South Texas Project  
Units 1 & 2  
Docket Nos. STN 50-498, STN 50-499  
STPNOC Second Six-Month Status Report in Response to March 12, 2012 Commission Order  
Modifying Licenses with Regard to Requirements for Mitigation Strategies  
For Beyond-Design-Basis External Events (Order Number EA-12-049)

**STP Nuclear Operating Company (STPNOC) Second Six-Month  
Status Report for the Implementation of Order EA-12-049, Order  
Modifying Licenses with Regard to Requirements for Mitigation  
Strategies for Beyond-Design-Basis External Events**

**Attachment 2**  
**Conceptual Drawings**

**Conceptual Drawing - FLEX Electrical Distribution System**

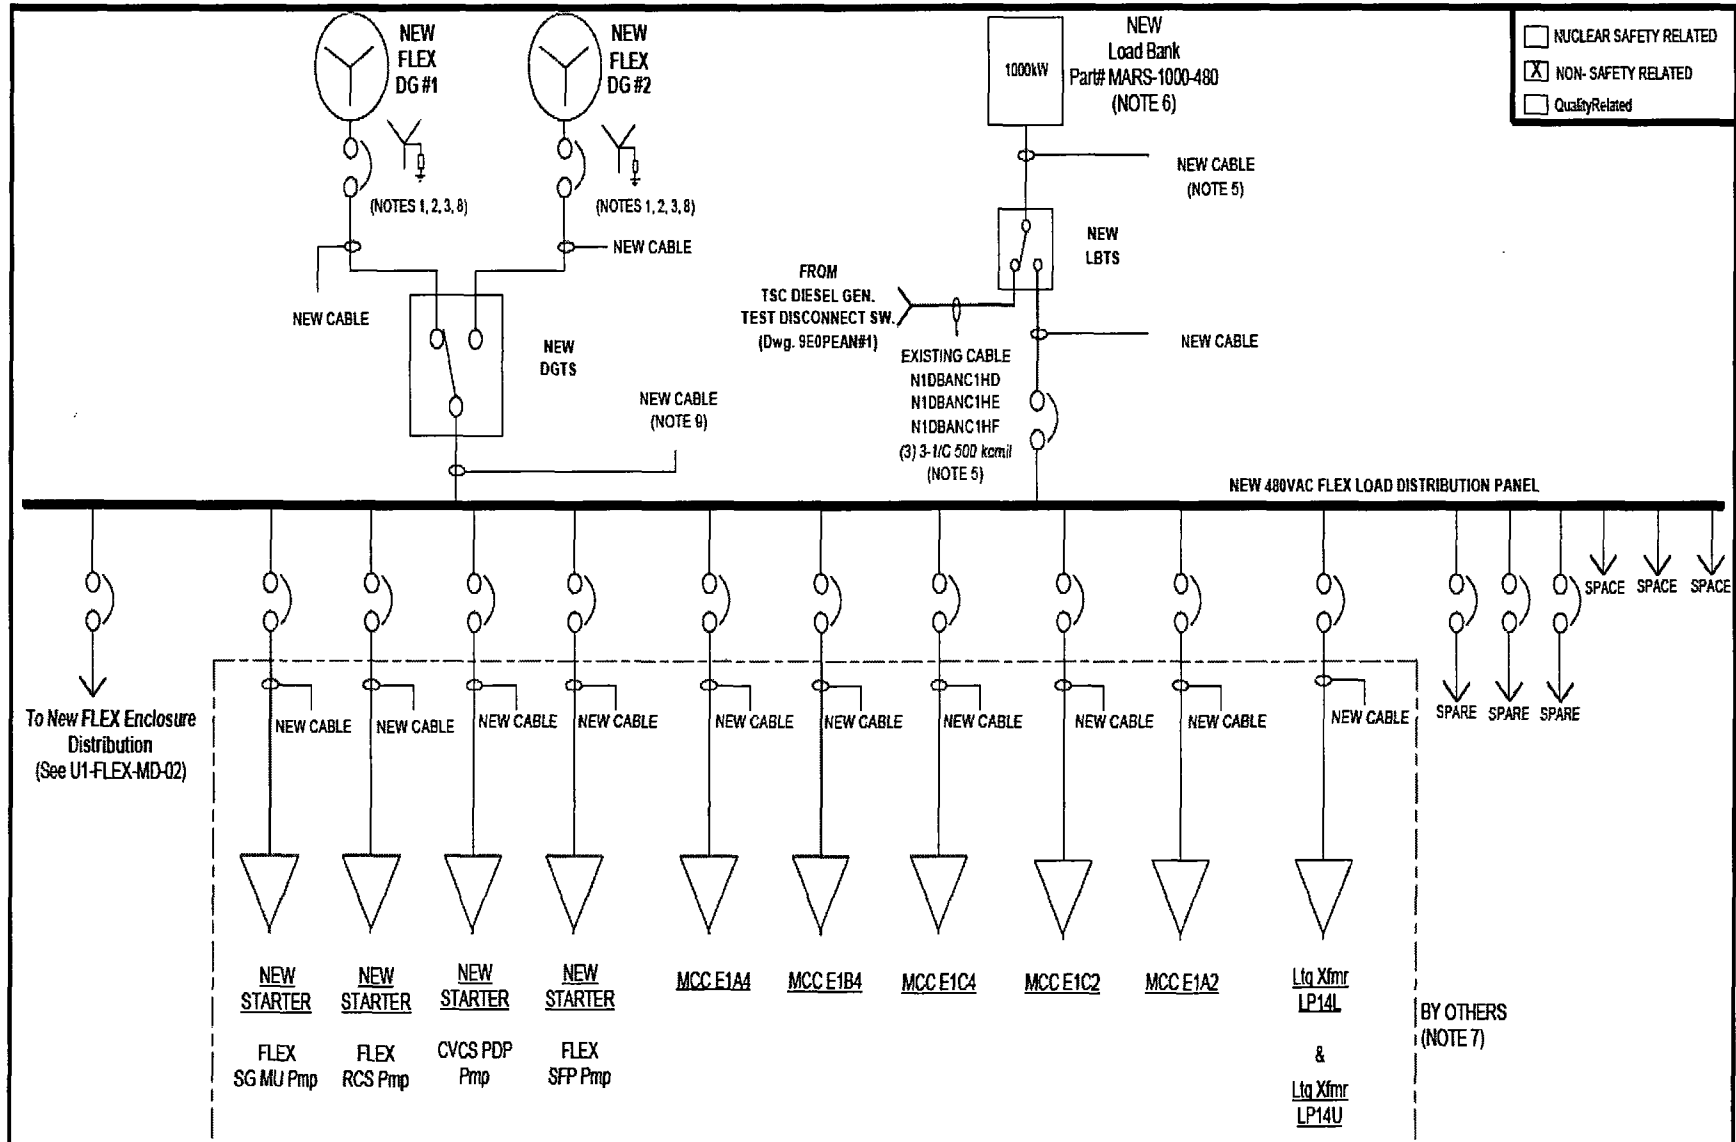
- F. The FLEX power diesel generator enclosures on top of the MAB will be made of steel vice concrete.
- G. For Modes 5 and 6 Core Cooling, a new FLEX pump rated at 170 gpm at 100 psig will be used as the primary strategy and a Boric Acid Transfer pump will be used as the alternate strategy.

See Attachment 2 for conceptual drawings and drawing changes planned for FLEX power distribution, SFP Makeup, RCS Makeup, and SG Makeup.

**Conceptual Drawing – Spent Fuel Pool Makeup FLEX Pump**

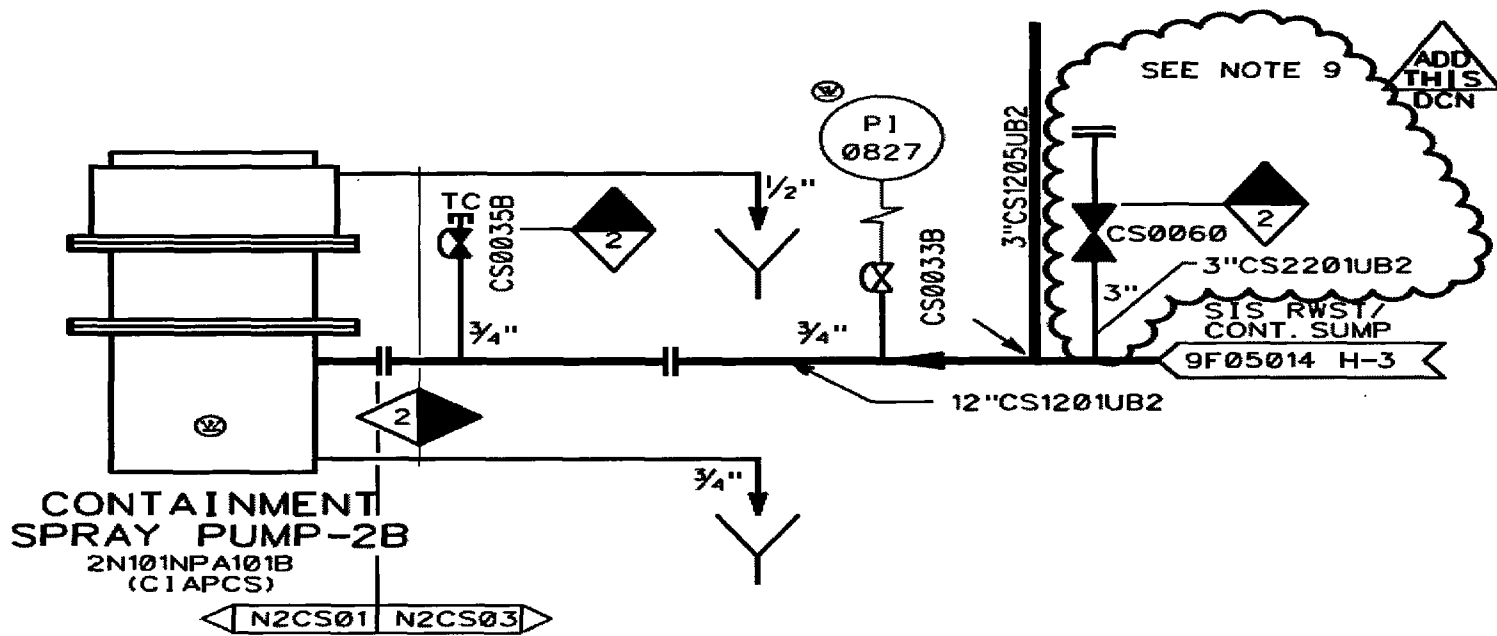
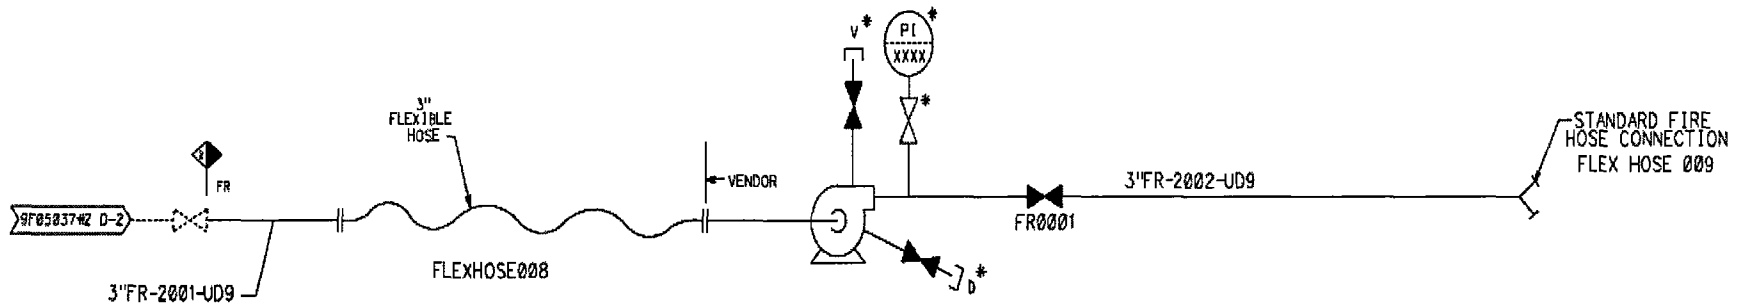
- The hose to the pool method will be a 250 gpm at 150 psi pre-staged FLEX SFP Makeup pump *in the FHB*. Hose fittings will be installed on the end of the pipe and temporary hoses will be staged in the area. Hoses will be routed from this location to the SFP. This FLEX pump suction is from the RWST.

- H. The new FLEX SFP makeup pump has been updated to a rating of 250 gpm at 150 psig. This pump will be used both for makeup using hoses and for spray.

**Conceptual Drawing – Reactor Coolant System Makeup FLEX Pumps**

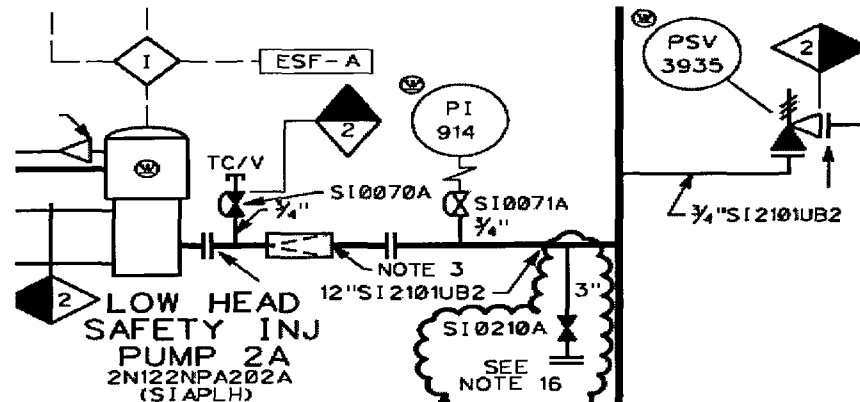
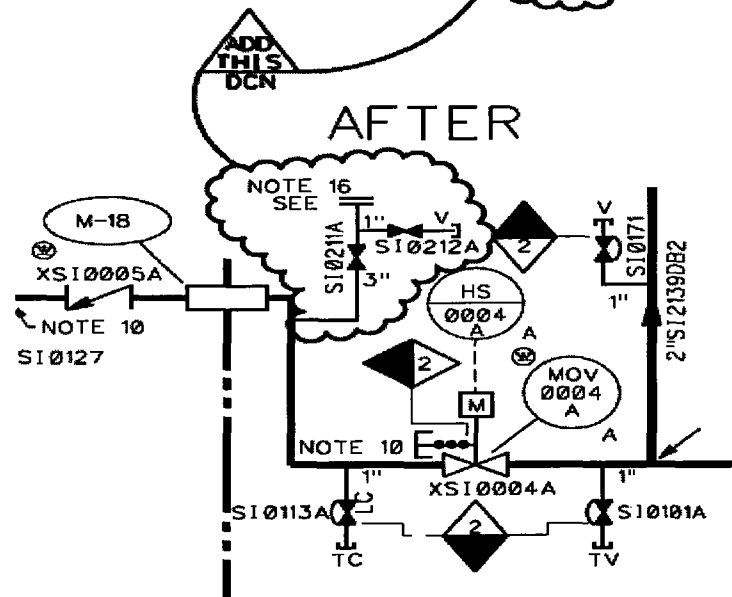
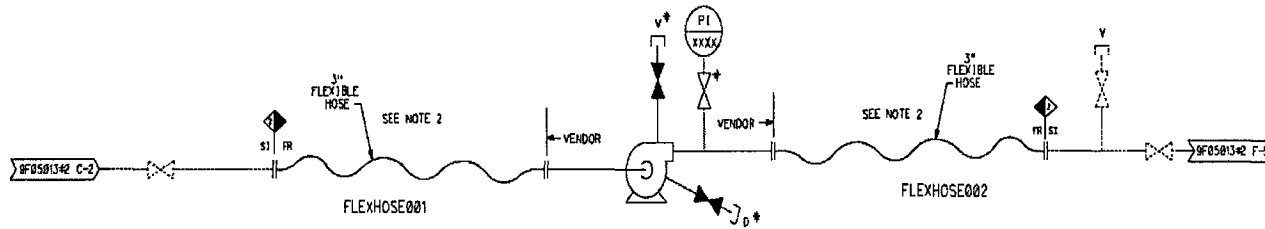
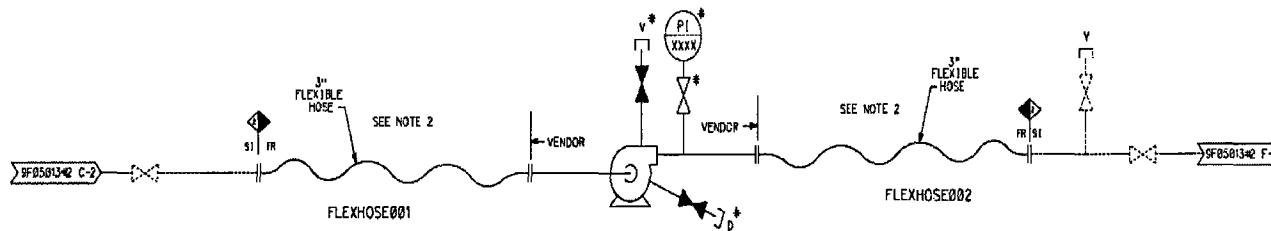
- D. The FLEX RCS Makeup pump was originally rated at 1500 psi but has been updated to a rating of 700 psi. STP can open the Reactor Head Vents as necessary during this event.

**Conceptual Drawing – Steam Generator Makeup FLEX Pump (RCS Core Cooling)**

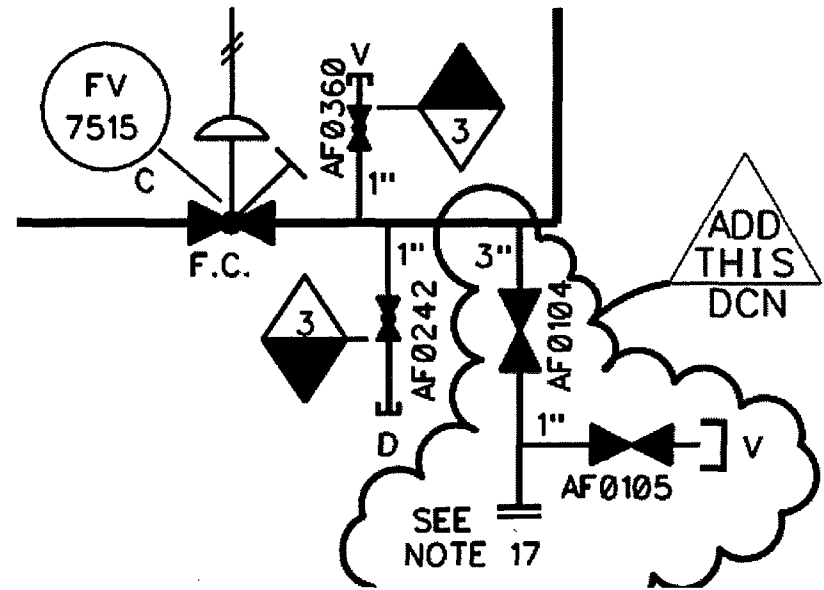
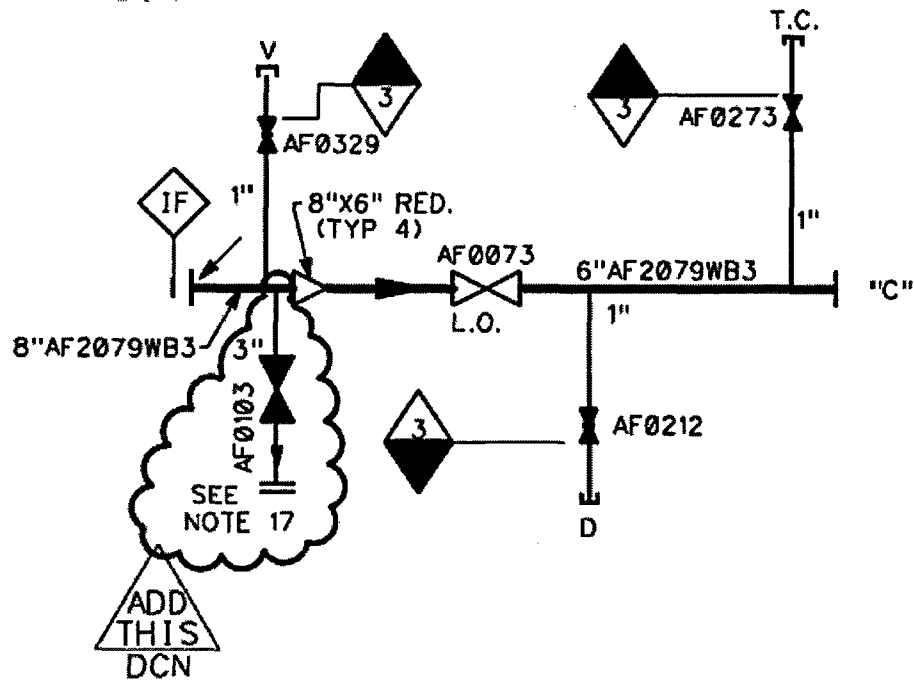
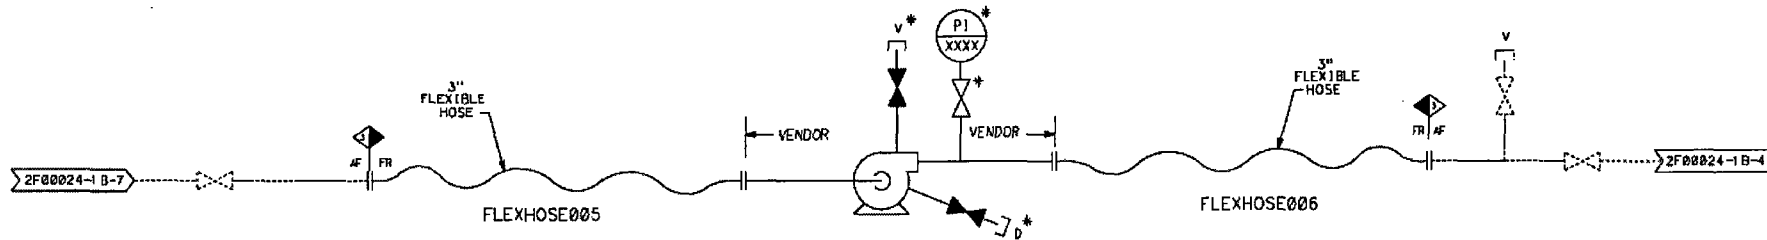
- a. Use the Turbine Driven Auxiliary Feedwater (TDAFW) pump in Phase 1.
  - b. Use the new 300 gpm at 500 psig FLEX SG fill pump as the primary strategy to back up the TDAFW pump during Phase 2.
